Re: Criteria Revision – Public

Public Comments
of
AGC Flat Glass North America, Inc.
to the
U.S. Department of Energy's
Energy Star Program's
Draft Report of Criteria and Analysis for Windows, Doors, and Skylights

**Showing Average Annual Home Energy Consumption ES 3
Using 0.35 and 0.30 U-factor and SHGC from 0.00 to 0.70**

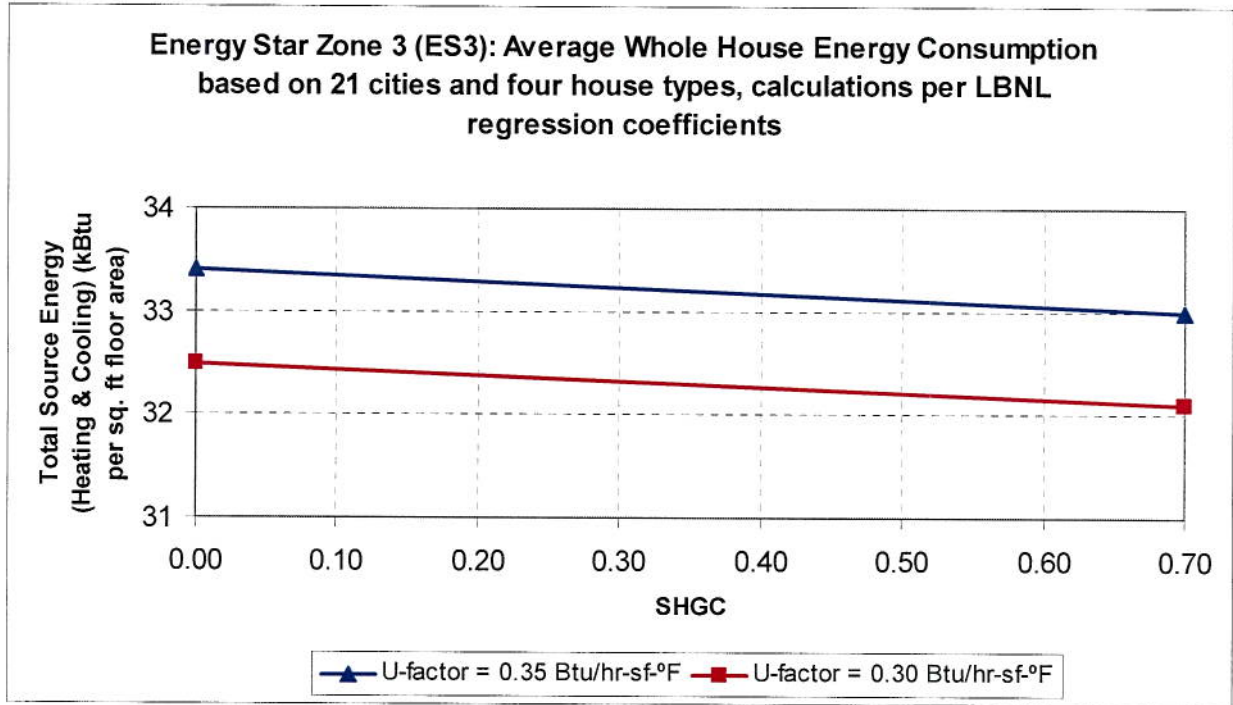
Appendices A, B and C attached hereto, graph the average energy consumption of homes in ES 3, 4 and 5, respectively. These graphs use the same cities and the same regression coefficients used to develop the current Energy Star Report. Each graph plots energy consumption against windows having 0.30 and a 0.35 U-factors, respectively, and against windows having SHGCs ranging from 0.00 to 0.70. As can be seen on each of the three (3) attached graphs, **as SHGC increases in ES 3, 4 and 5, total annual energy consumption decreases**. The further north you go, from ES 3 to ES 5, the larger, or steeper, the decrease in total average energy consumption.

In short, beginning in ES 3 and going north to ES 4 and 5, higher SHGC windows reduce annual energy consumption by using the renewable, non-polluting energy of the sun as a home heating fuel, thus, reducing the amount of fossil fuels that need to be burned to heat these homes. However, these energy conservation facts often conflict with the desire of some marketers of low SHGC products to market a single, low SHGC product nationally from Miami to Canada.

**Showing Average Annual Home Energy Consumption ES 4
Using 0.35 and 0.30 U-factor and SHGC from 0.00 to 0.70**

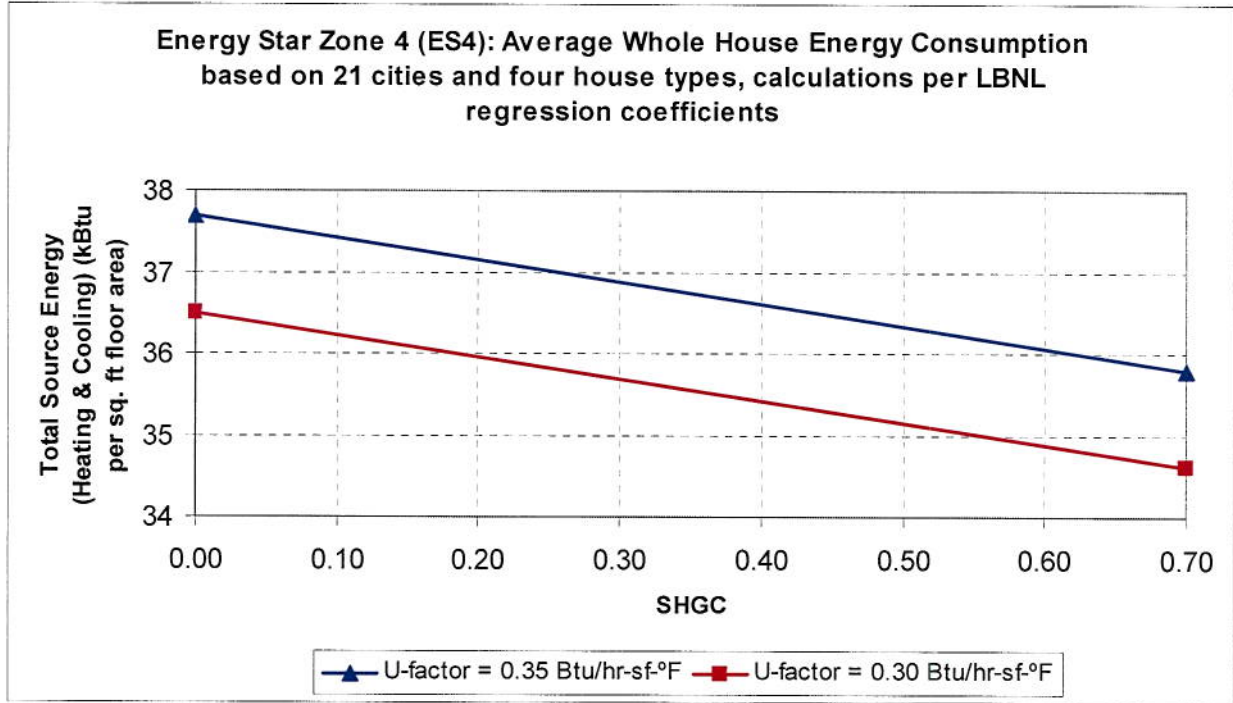
³ The penalty for installing low SHGC glass in the northern US or Canada in a home with 200 square feet of windows during a 212-day heating season will be that the homeowner will have to burn an additional 4 million BTUs of fossil fuel to compensate for the loss of heat that would be supplied from the sun if high SHGC windows were used. *Energy Design Update*, Vol. 26, No. 11, Nov. 2006, p. 13 (Aspen Publishers). This is more specifically demonstrated in ES 4 and 5 by the energy consumption graphs attached hereto as Appendices B and C.

Nowhere in the Energy Star Report is there citation to any objective evidence of any kind to support DOE's proposed inclusion of a 0.55 SHGC cap in ES 4 or 5 in Phase 1 or Phase 2. In fact, the objective evidence is to the contrary. **SHGC levels above the proposed 0.55 cap will save more energy than SHGC levels below the proposed 0.55 cap in ES 4, and will save even more energy in ES 5.** See, Appendices B and C attached hereto.

4. The Energy Star program is “designed to help reduce national energy consumption by increasing the energy efficiency of fenestration products in residential buildings.” Energy Star Report, p. 4. As demonstrated in Appendices B and C, eliminating the 0.55 SHGC cap in ES 4 and 5 will help achieve the objective of reducing national energy consumption.
5. Nowhere do subjective criteria such as “overheating,” “discomfort,” or “customer dissatisfaction” appear amongst any of the “guiding principles” that should be applied in revising the Energy Star criteria.⁴
6. Use of subjective criteria, such as overheating, discomfort or customer dissatisfaction, can result in the arbitrary exclusion of energy efficient products from the Energy Star Windows Program.

There is no legitimate basis for the imposition of a 0.55 SHGC cap and it will arbitrarily disqualify energy efficient products from qualifying for an Energy Star label. The 0.55 SHGC cap should be eliminated from the Phase 1 and 2 criteria for ES 4 and 5.
